The 55 details drawn differently in CAD and Revit

Checked against the new drafters' file, 26 October.

55 of the 190 CAD typical details have a Revit version in your templates that is drawn differently. Each page: your CAD detail on the left, the Revit version on the right, what differs, and one answer: CAD is right, Revit is newer (we update CAD from it), or both wrong.

Revit: D5.02_3_BRICK LEDGER DETAIL (Typical Details - Container_R23 (Need_MET & IMP).rvt; on D5.02 Series 5 Miscellan)

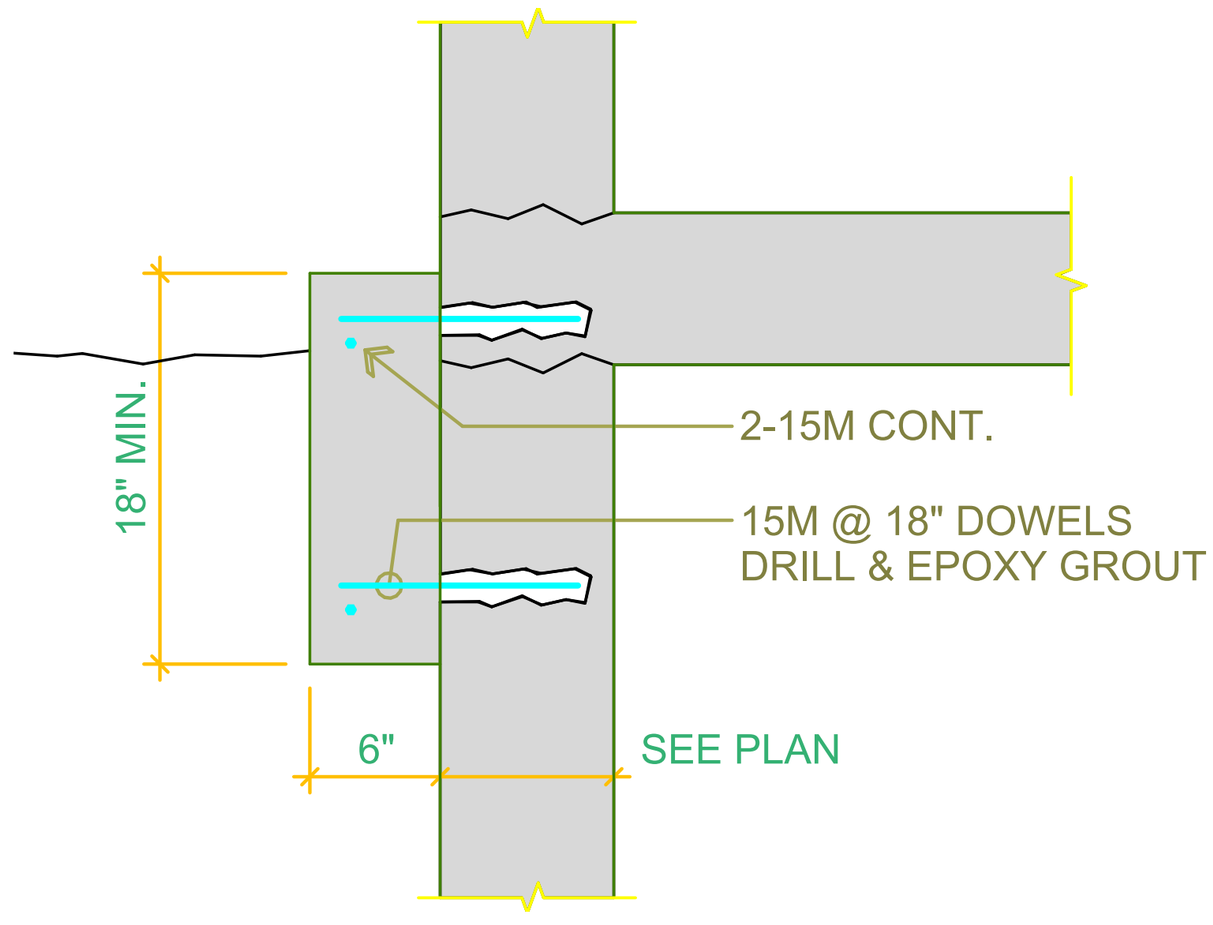
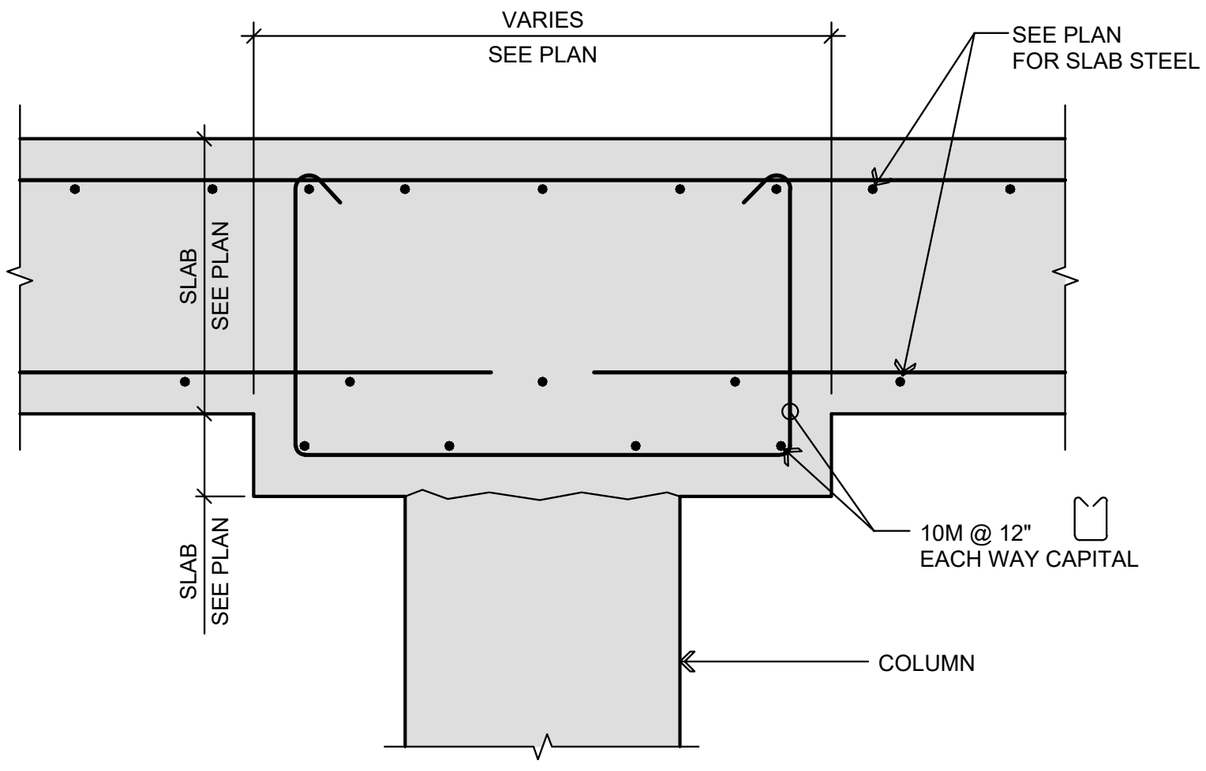
What differs: Both brick ledgers, but CAD is a post-cast ledger with 45 deg epoxied bars, Revit a cast ledger with horizontal dowels.

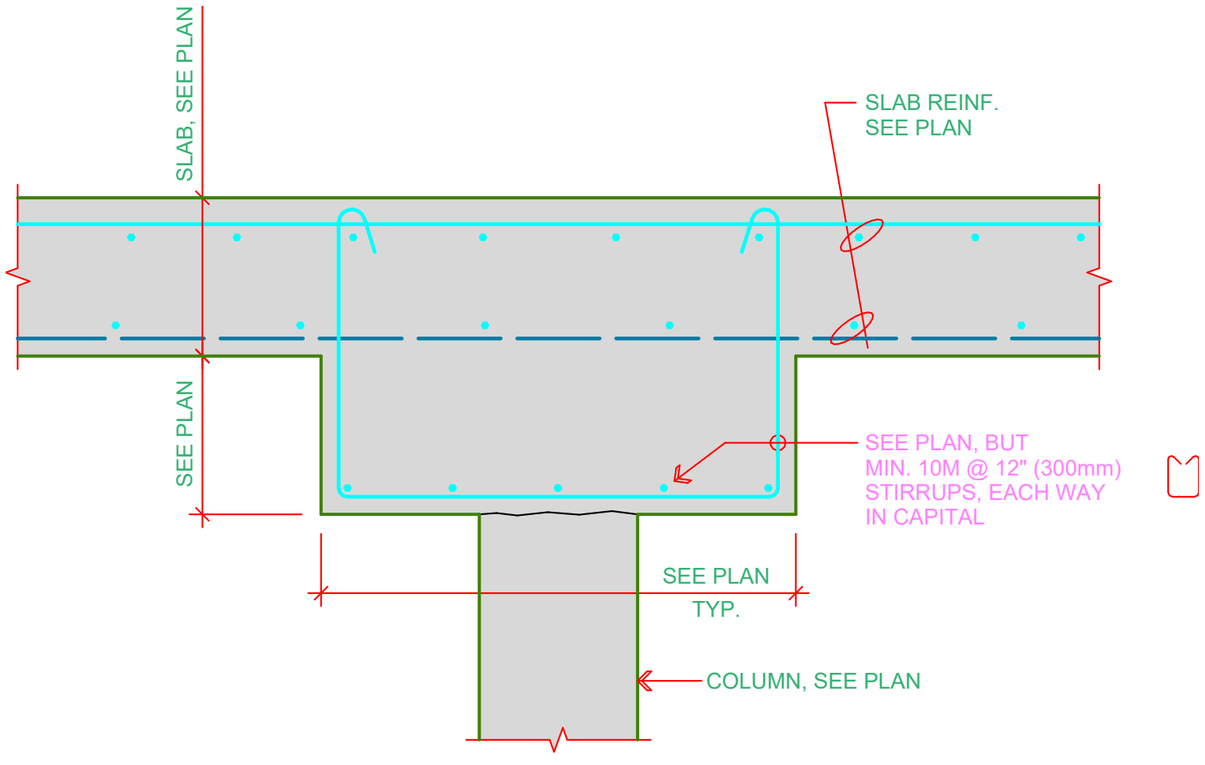
What differs: Column capital but CAD capital is wider with a different bar arrangement and no hooked top bars.

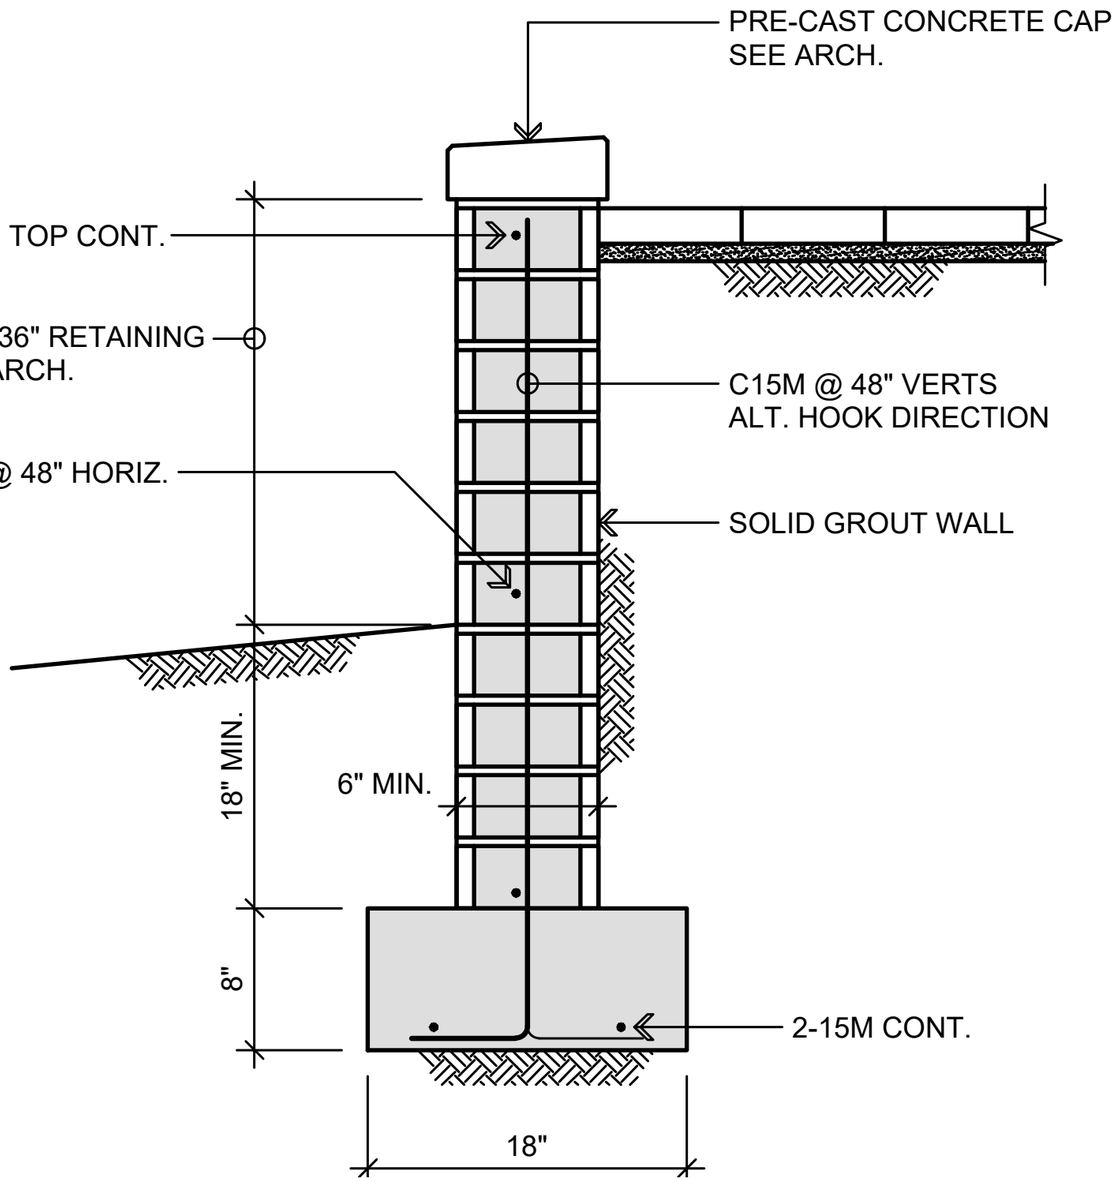
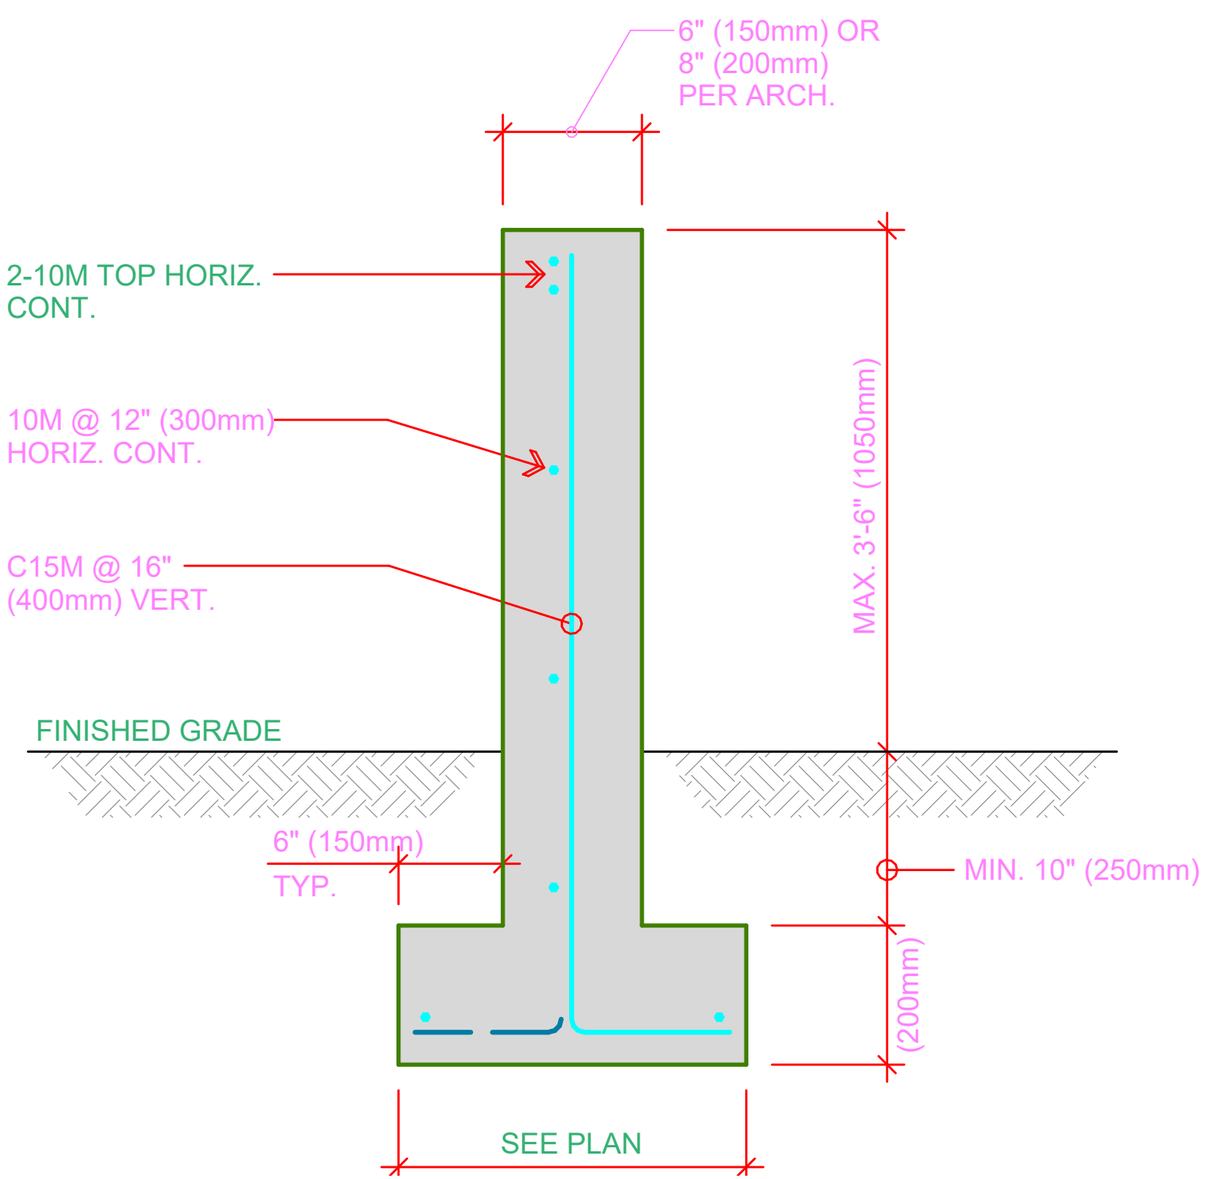
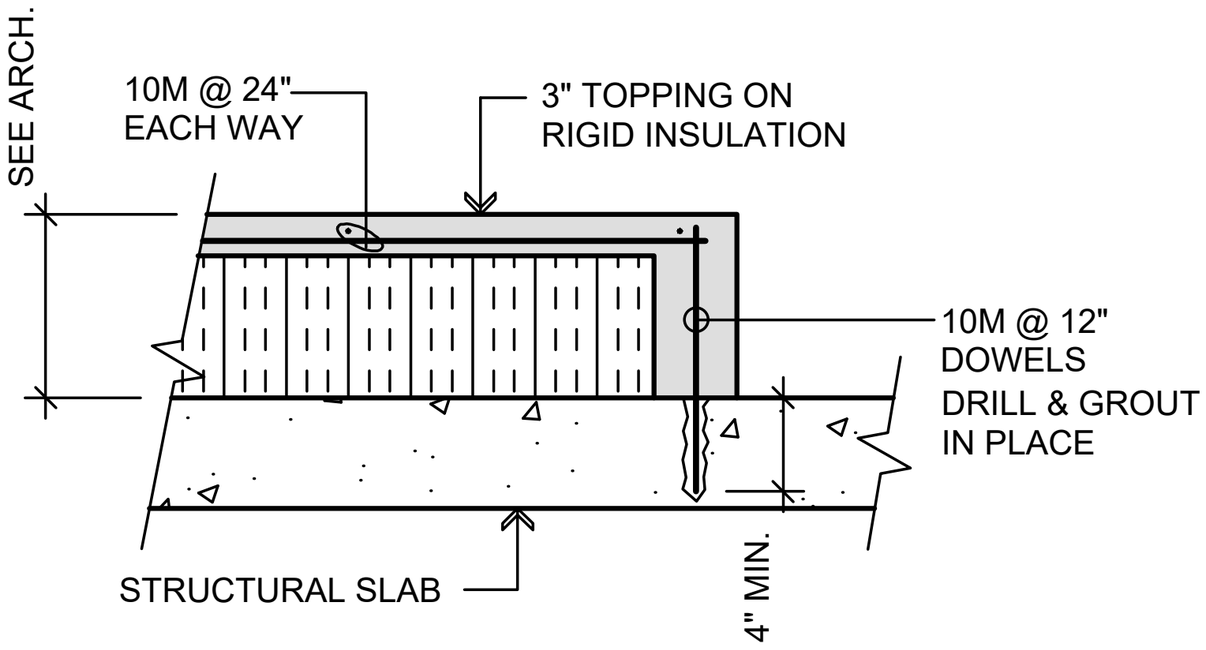
What differs: Both low site walls on footings, but CAD is a grouted masonry retaining wall with precast cap, Revit a concrete wall.

CAD: KOR-D502-DET 34 - BUILT-UP SLAB DETAIL

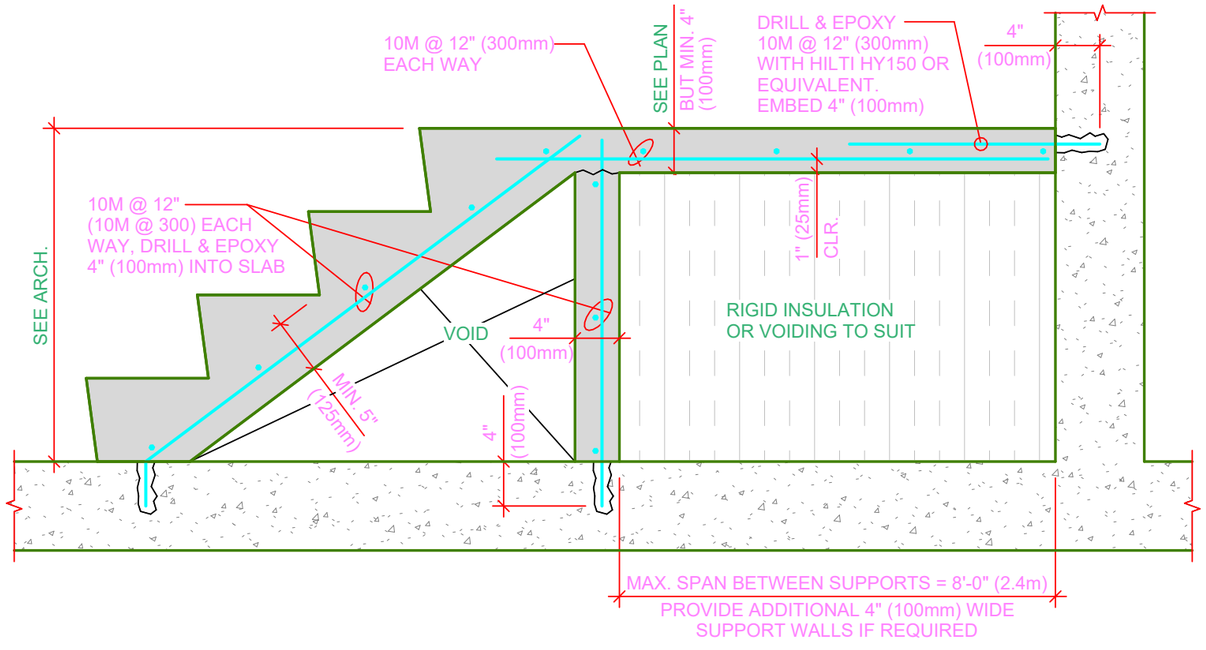
What differs: Both built-up slabs with rigid insulation, but CAD is topping on insulation with dowels, Revit a stepped fill with support walls.

Revit: D5.02_7_SANDWICH SLAB DETAIL (Typical Details - Container_R23 (Need_MET & IMP).rvt; on D5.02 Series 5 Miscellan)

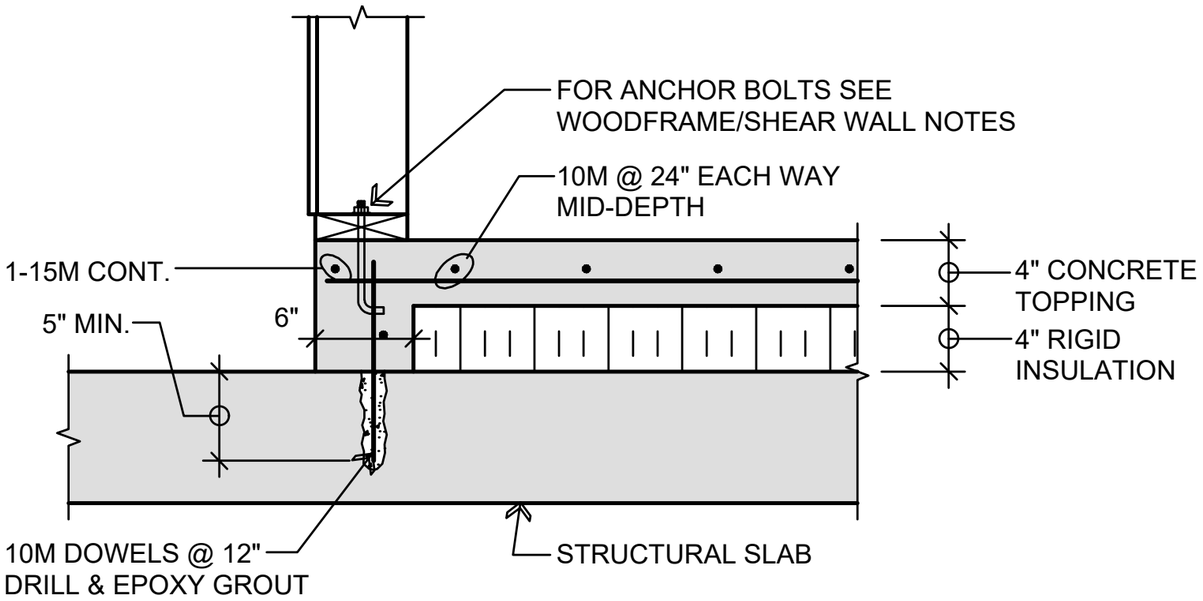
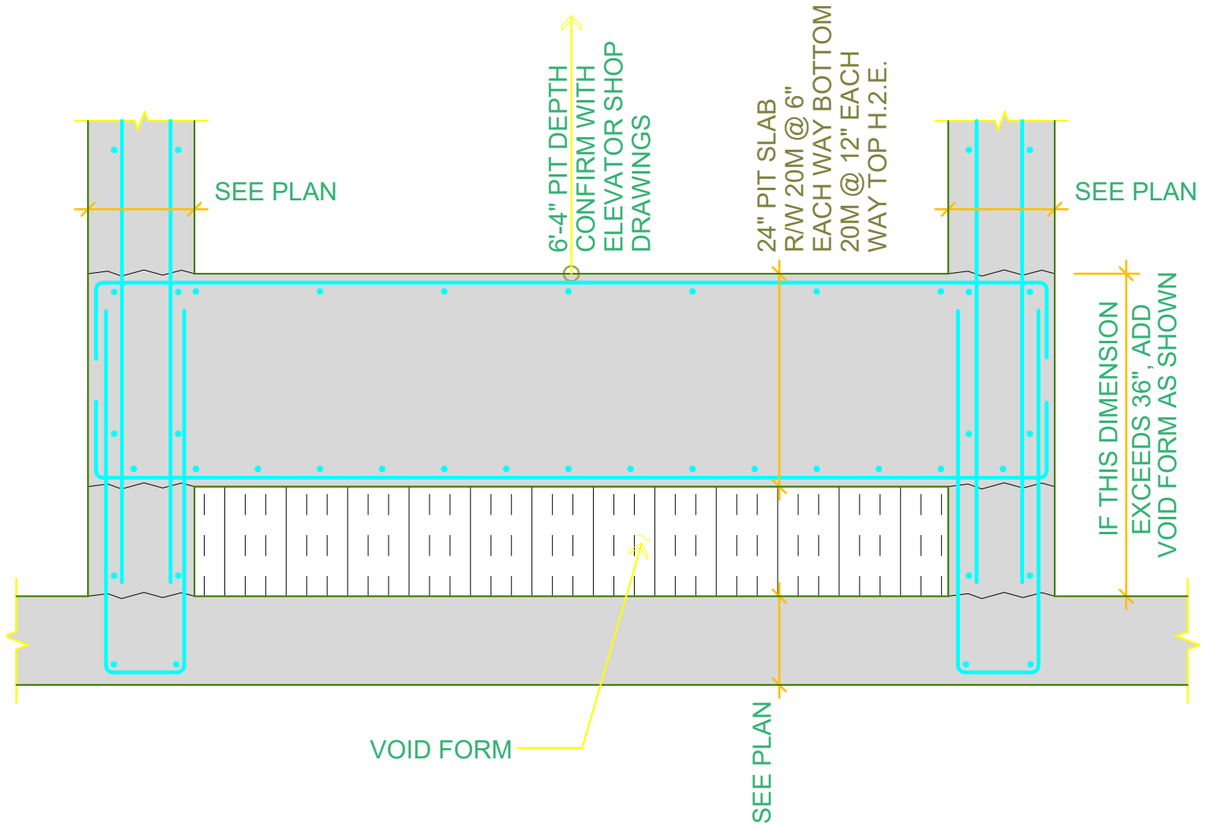
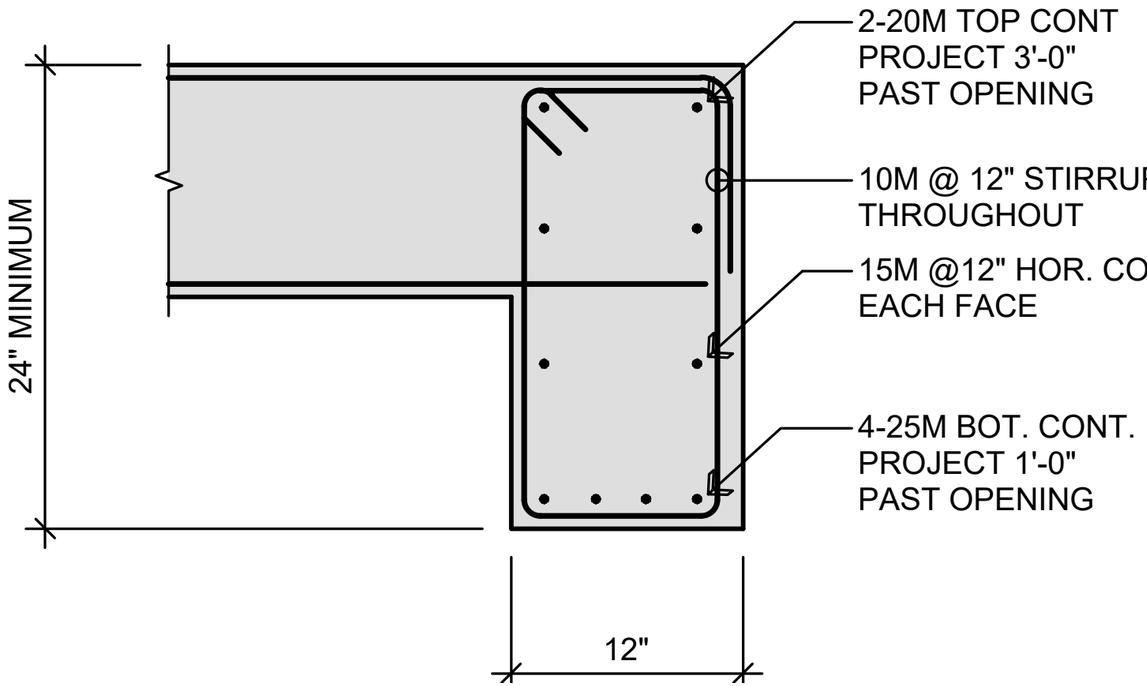
What differs: Same title, but CAD is topping on rigid insulation over structural slab, Revit a slab over void form at a pit.
